2. AMENDMENT/MODIFICATION NO. 0007	3. EFFECTIVE DATE 06/07/02	4. REQUISITION/PURCHASE REQ. NO.	5. PROJECT NO. (If applicable)
6. ISSUED BY CODE US ARMY ENGINEER DISTRICT, HONOLULU CORPS OF ENGINEERS, BUILDING S-200 FORT SHAFTER, HAWAII 96858-5440 CONTRACT SPECIALIST: JODY MURAOKA		7. ADMINISTERED BY (If other than Item 6) CODE

FY02 DLA MILCON KNMD 003002, Replace Hydrant Fuel System, Hickam Air Force Base, Oahu, HI

REPLACE HYDRANT FUEL SYSTEM
HICKAM AIR FORCE BASE, HAWAII
AMENDMENT 0007

project	25686
contract	
SK -	A1

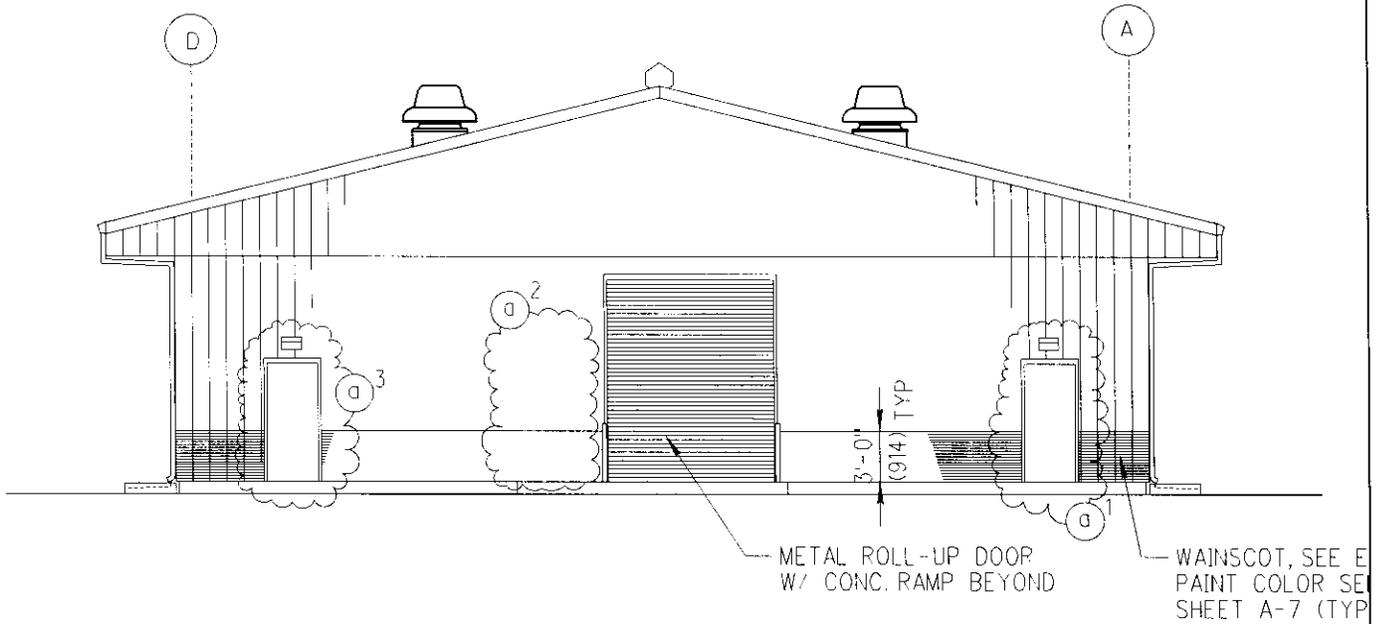
- (1) Sheet No. C-4. At Zone F5, add two (2) new door stoops on east end of Pumphouse, one near the north corner and one near the south corner, as shown on attached sketch SK-A1. At Zones F/G5 move the north/south oriented sidewalk 5 feet away from the edge of the Pumphouse, and add "5' (1.52m)" dimension showing location.

- (2) Sheet No. C-10. At Zone F5, add two (2) new door stoops on east end of Pumphouse, one near the north corner and one near the south corner, as shown on attached sketch SK-A1. Add spot elevations of 9.90 at edge of north stoop. At Zones F/G5 move the north/south oriented sidewalk 5 feet away from the edge of the Pumphouse, adjust spot elevation 9.40 to read 9.75.

- (9) Sheet No. A-1. At Zones F3/4/5, add new door, "1/08", at northeast corner of Pumphouse and relocated door "1/04" to southeast corner as shown on attached sketch SK-A1.

(12) Sheet No. E-13. Move type ERX and C light fixtures (and door) at drawing coordinates H4 to positions centered over new location of door at drawing coordinates H2. Move ER light fixture near drawing coordinates G6 to position centered over new door being added near drawing coordinates H6, and make fixture ERX type. Add exterior light fixture type C over same door. Connect to exterior lighting circuit PA-8 using 3/4" galvanized rigid steel conduit and extended from relocated type C fixture over door at drawing coordinates H2. Provide conduit seals where entering/leaving hazardous areas. See Sketch SK-A1 for new door locations.
